EDGE-ON-HUDSON

APPLICATION FOR SITE PLAN & SUBDIVISION APPROVAL

PHASE ONE SUPPLEMENTAL SUBMISSION 2

Re: Phase 1 Site Plan and Subdivision Application
Edge-On-Hudson Riverfront Development
199 Beekman Avenue, Sleepy Hollow

Red Crosswalk - Interlocking Concrete Pavers with Concrete Banding

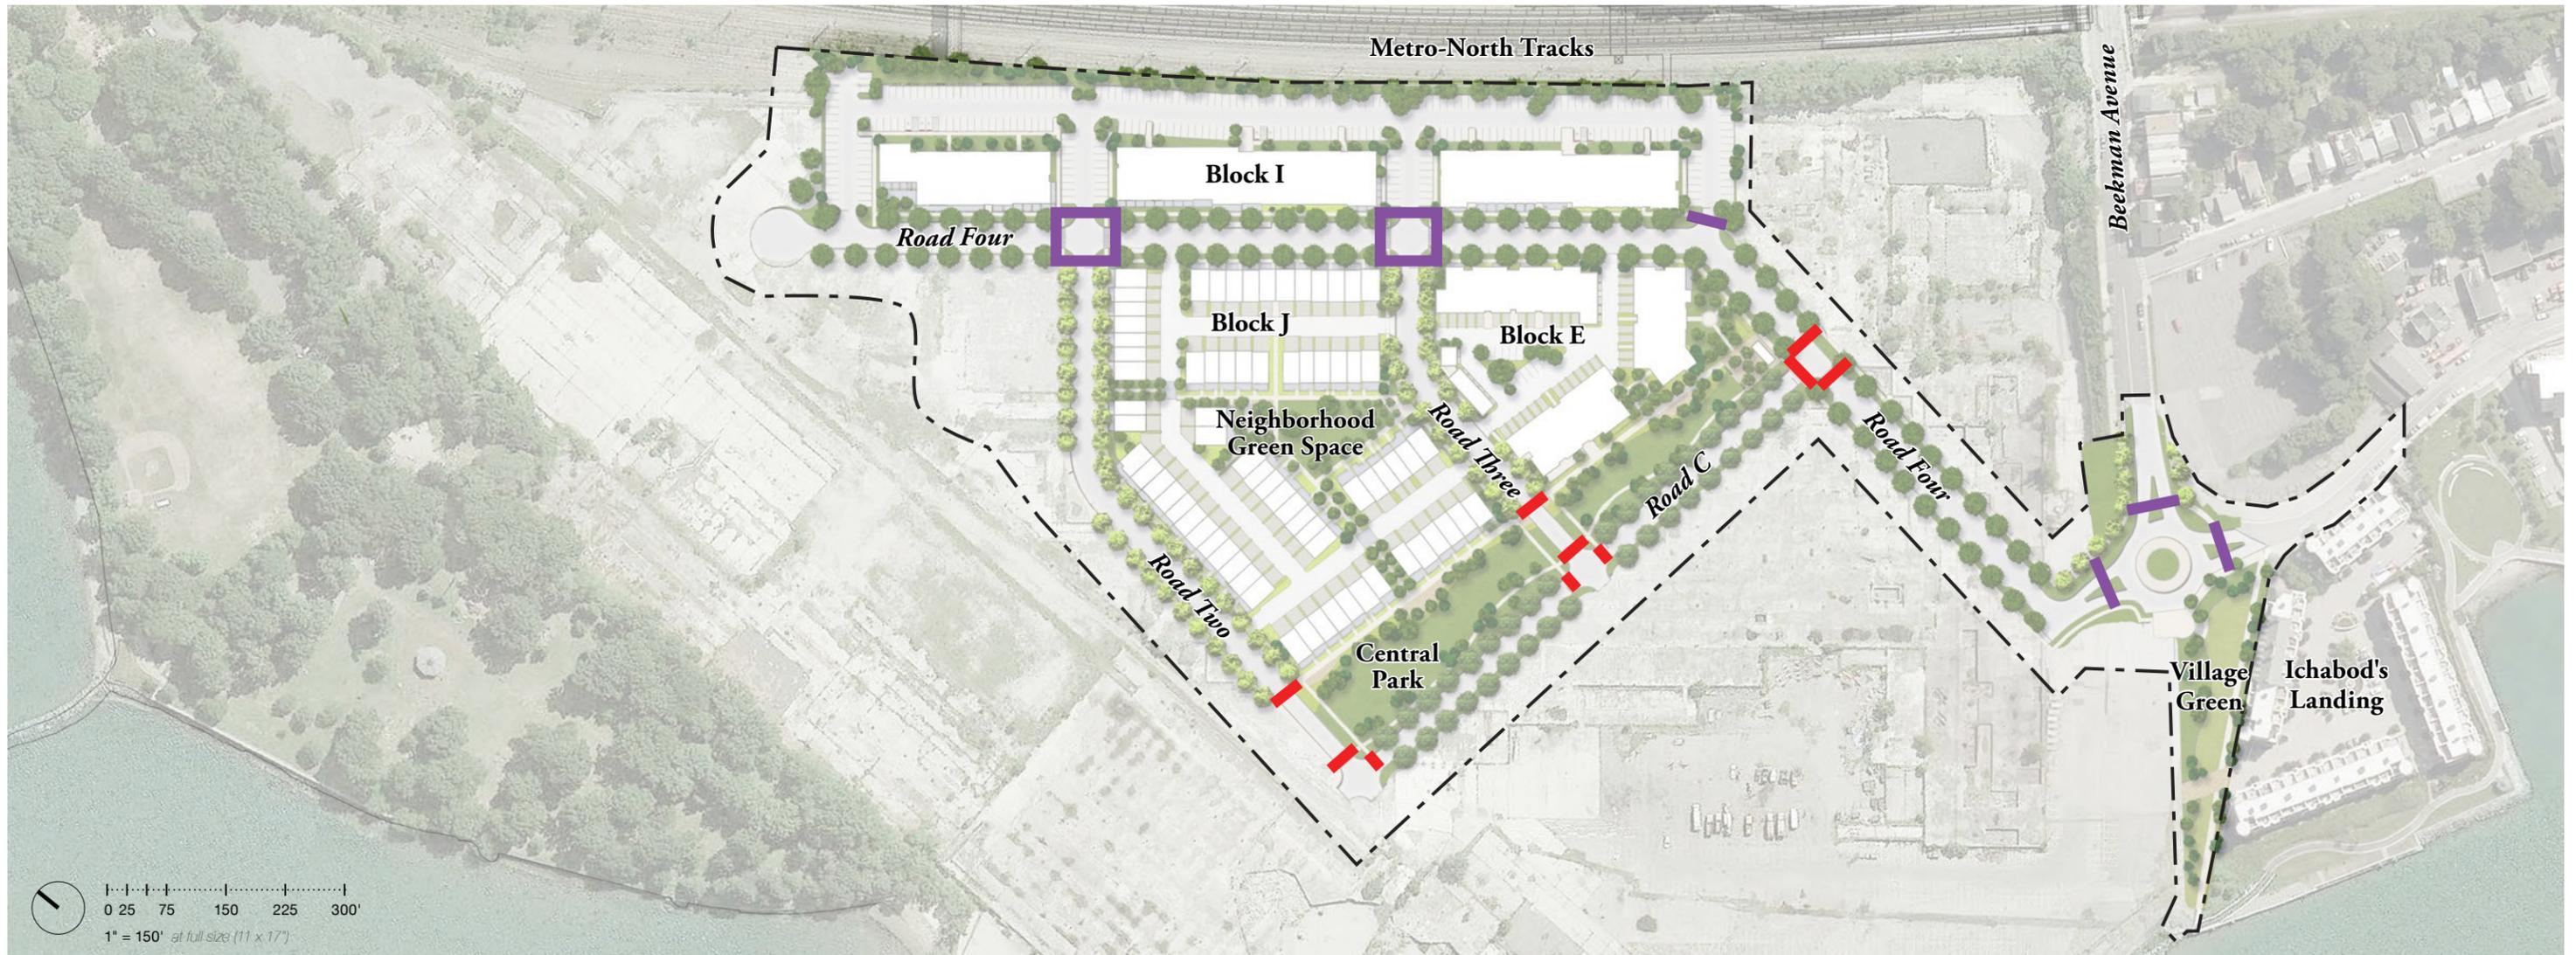
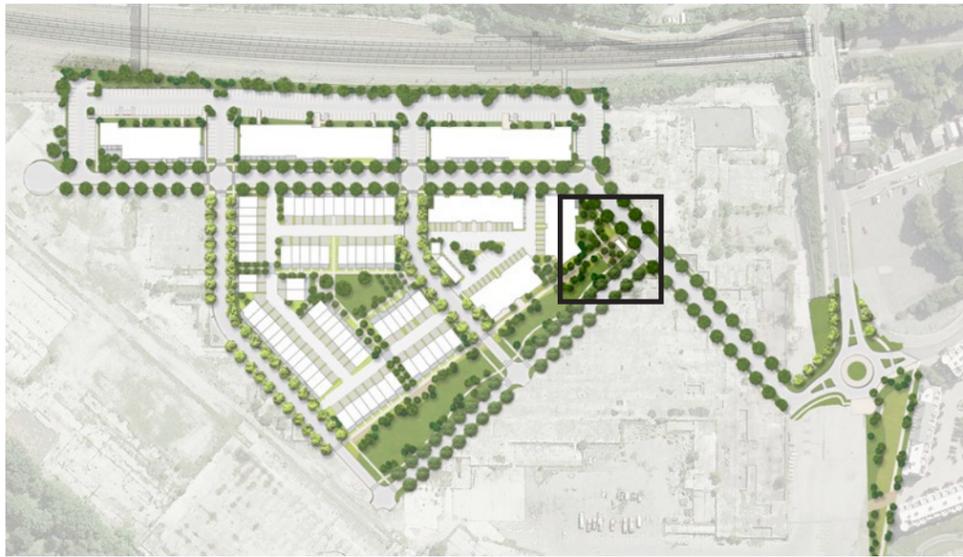
1. **Comment:** *The Applicant has indicated that they are proposing to use painted crosswalks in the Central Park District as illustrated on the Central Park: Materials sheet. This design treatment is inconsistent with the intentions of the Design Guidelines which specifically calls for special paving treatments. It is suggested that the Applicant provide the Planning Board with some examples of special paving treatments that could be applied throughout the Central Park District. Details in the Landscape Architecture section of the Phase One Supplemental Submission should be coordinated and consistent with the large scale plans.*

Response: The Applicant is proposing to utilize interlocking hexagonal block asphalt pavers on the Neighborhood Walkway in the Central Park district. Decomposed granite paving will be used on all other pathways in the Central Park district. The crosswalks within the Central Park district are proposed to be concrete pavers with a concrete accent band. The crosswalks on Road Four near the entrance to the Central Park will also receive this treatment. *See Hardscape Materials: Paving and Hardscape Materials: Crosswalks* for more details on the proposed materials.

Company: Fermob
Model: Park Bistro Table & Chairs
Material: Steel
Color: Black Powder Coat Finish

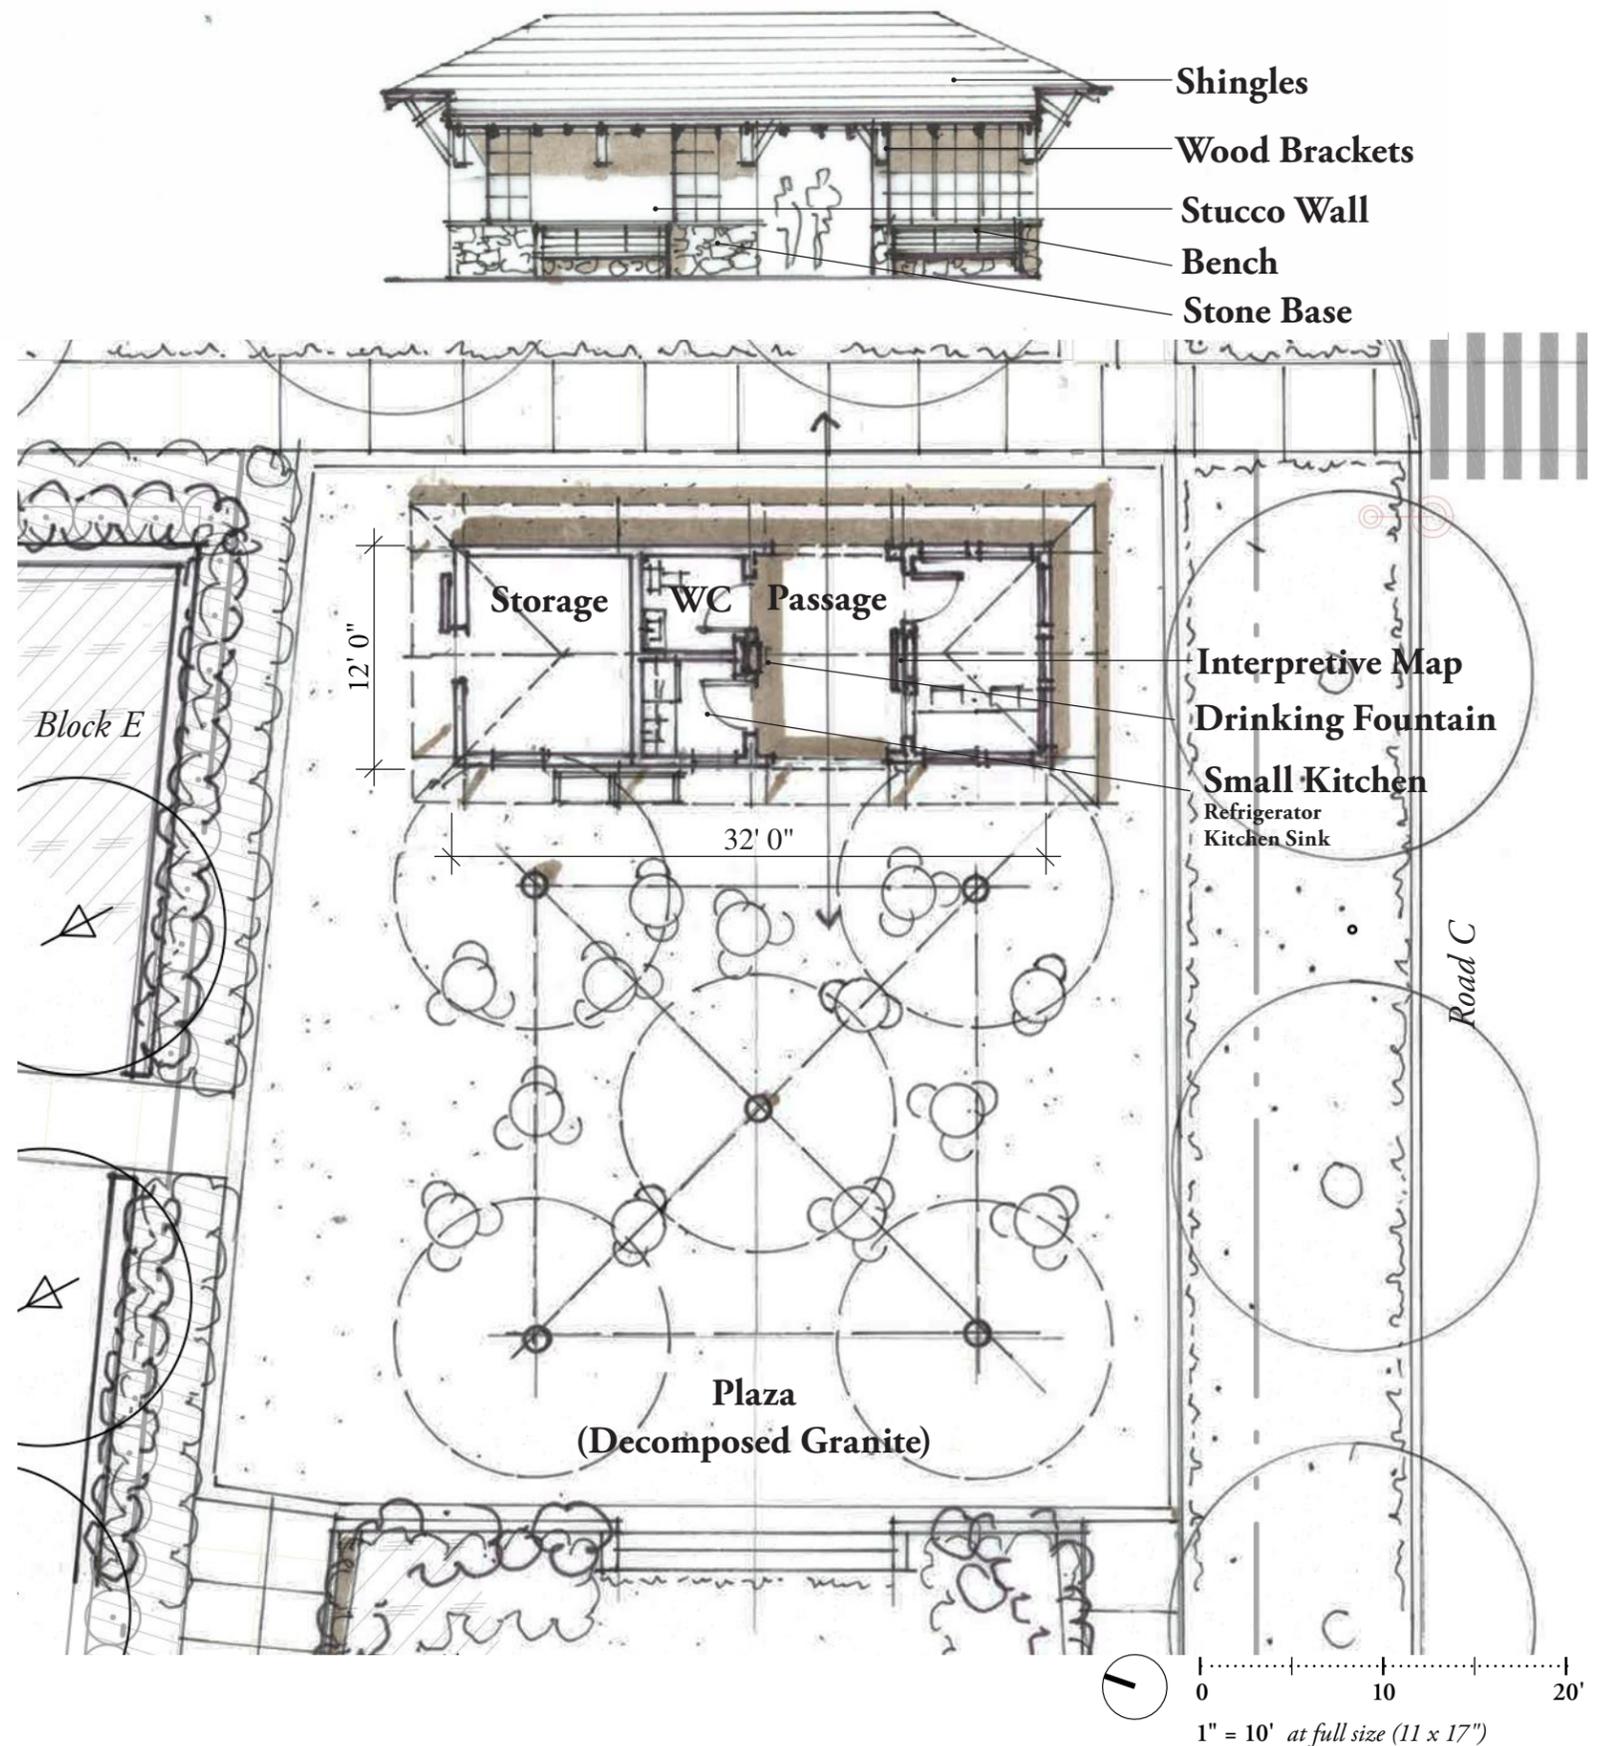
8. Comment: *The Applicant has provided some additional details on the Market Courtyard concept, however, it doesn't appear to be reflected on the large scale site plan drawings. Given its prominent location and the intention of acting as a community space it is suggested that additional furniture (chairs and tables) be added as an amenity, consistent with other comparable urban open spaces. The programming and maintenance of areas like the Market Courtyard are issues for the Village of Sleepy Hollow to consider with the Applicant. It would be important to hear from the Village Administrator as to how the Village handled the Ichabod's Landing waterfront open space and whether there are any lessons learned that should be applied to the new landscapes to be made available to the public. Does the Village want to continue to maintain public open space in the Riverfront District or is there an alternative arrangement with Applicant. One of our earlier comments raised the issue of how a homeowners association (HOA) would address maintenance of the private areas of the site. If there is going to be some arrangement between the Village and the Applicant regarding maintenance there should be some language relative to how this would work and the responsibilities of both parties. This issue takes on even more importance later in the site development process once the waterfront open space becomes available.*

Response: Within the proposed Market Courtyard, the Applicant is proposing a small pavilion of approximately 32 × 12 feet. This structure will have a stone base, stucco wall and shingle roof and will open onto a plaza comprised of decomposed granite. There will be a passageway

through the building connecting the Central Park area with the Market Courtyard and Road Four. Inside the structure will be ample storage for the moveable bistro chairs and tables.

Company: Modern Design Site Furnishings
Model: Vera bench with arms
Material: Jatoba hardwood seat and steel back
Color: Black Powder Coat Finish

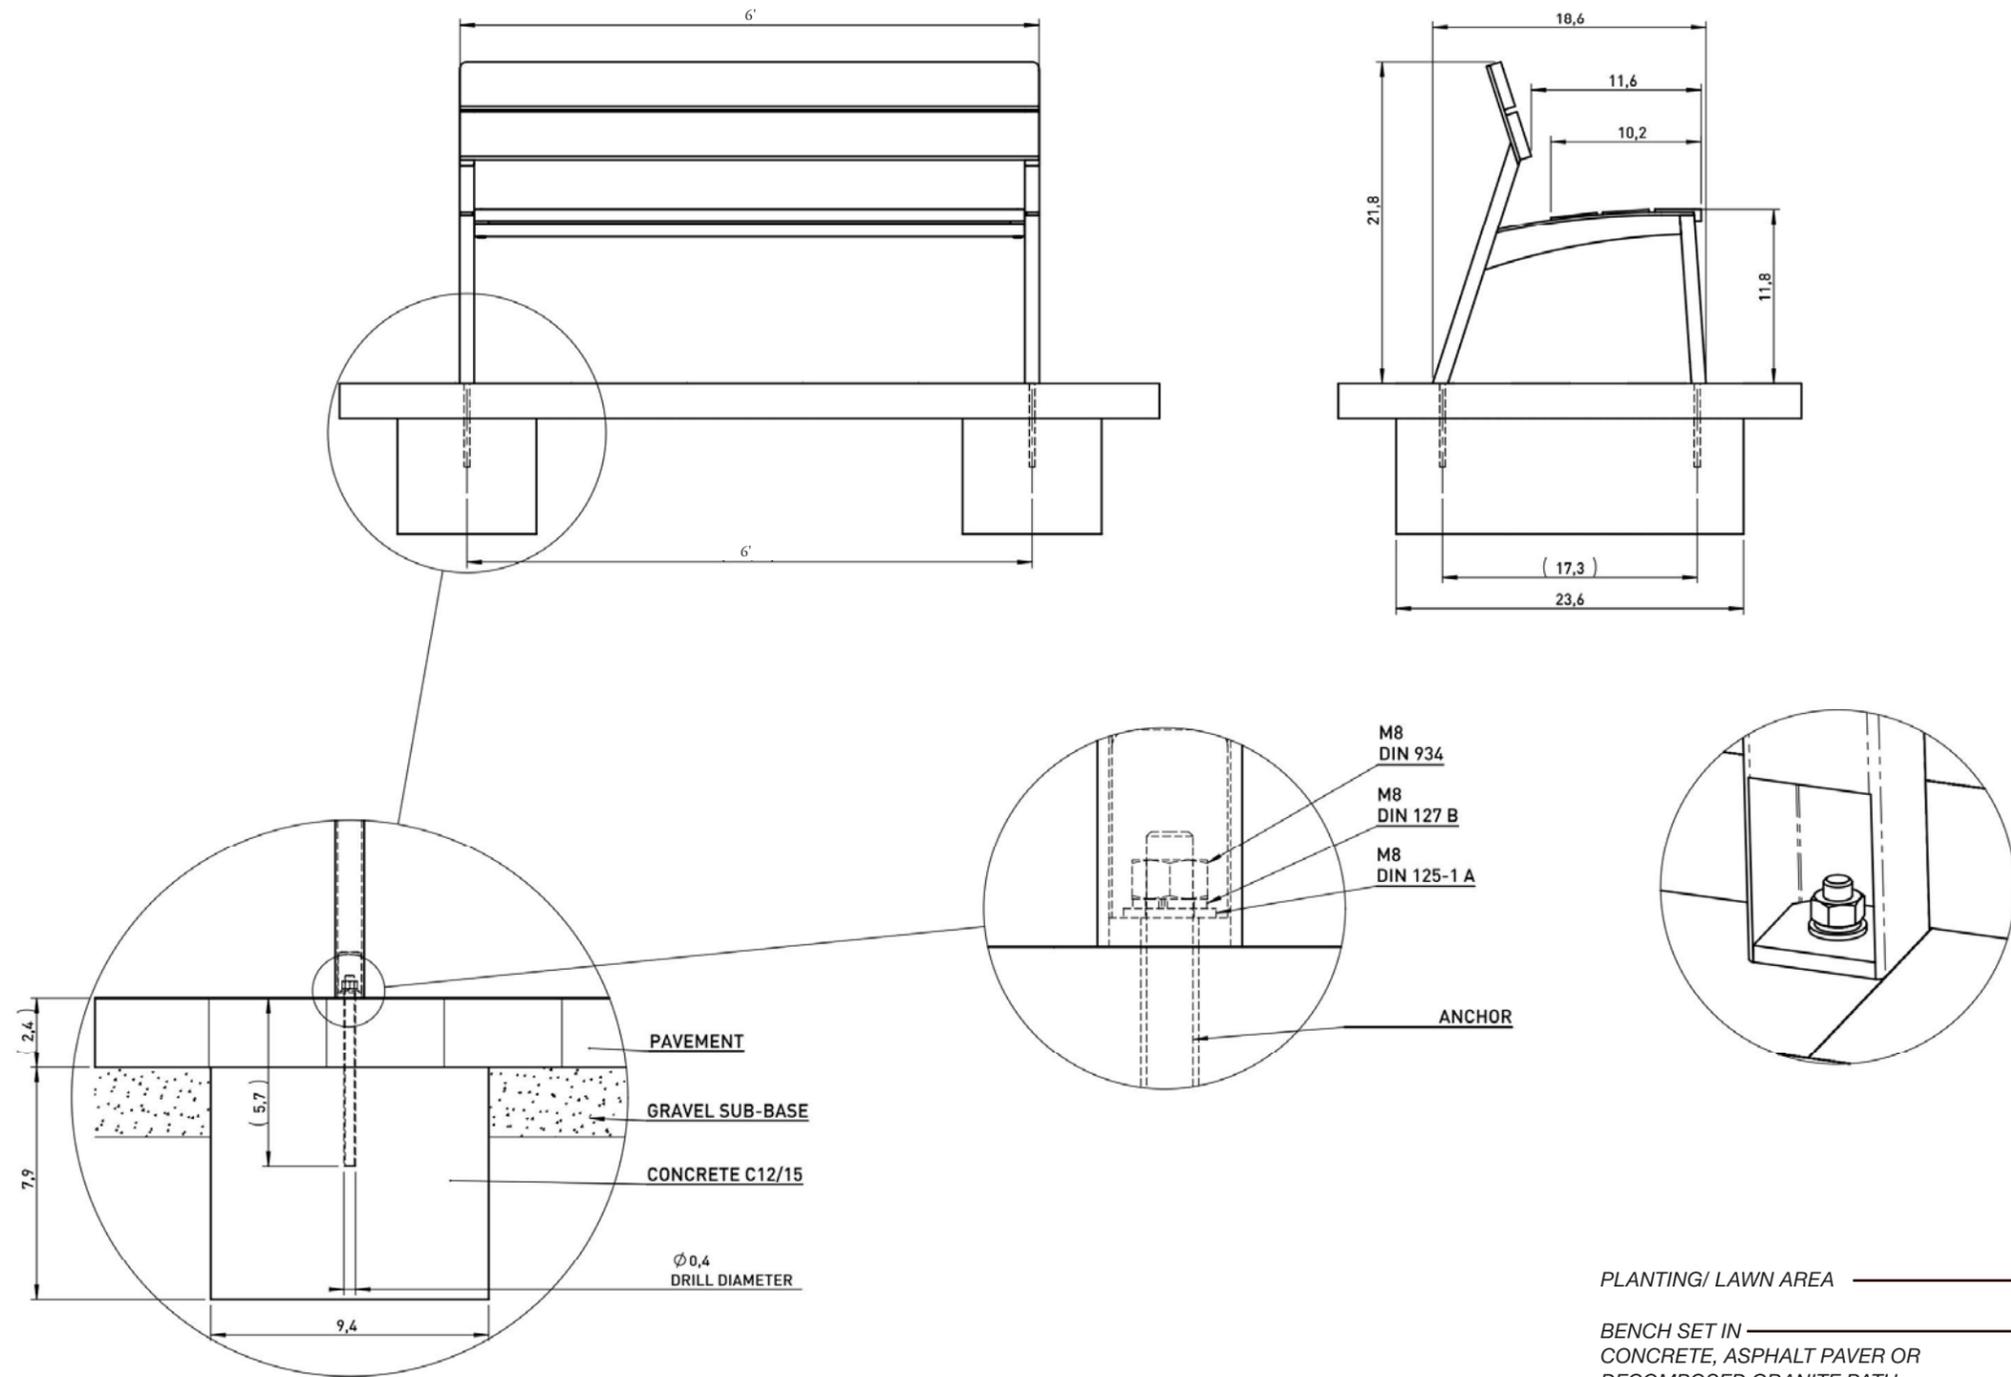
3. **Comment:** *It is noted that at the July 2015 presentation to the Planning Board, one of the first comments from the Planning Board related to the appearance of the proposed benches. One of the standards identified in the Design Guidelines is the use of quality materials – quality materials age well, stand up to abuse and have a comparatively long life expectancy. While there are limited examples of street furniture, like benches, refer to pages 17, 20, 21, 22, 50 in the Design Guidelines, it would be helpful if the Applicant could provide some additional background on the type of benches proposed and where those elements have been used in other park settings.*

Response: In keeping with the standards identified in the Design Guidelines which stress the use of quality materials, the benches proposed for the Edge-on-Hudson development will have a steel structure and a back cured with a powder coat finish and a Jatoba hardwood seat. According to the web site of Modern Design Site Furnishings, the seat and backrest are joined firmly together to the supporting frame. All four legs of the bench can be easily anchored to the ground as illustrated on *Site Amenities: Seating Installation*.
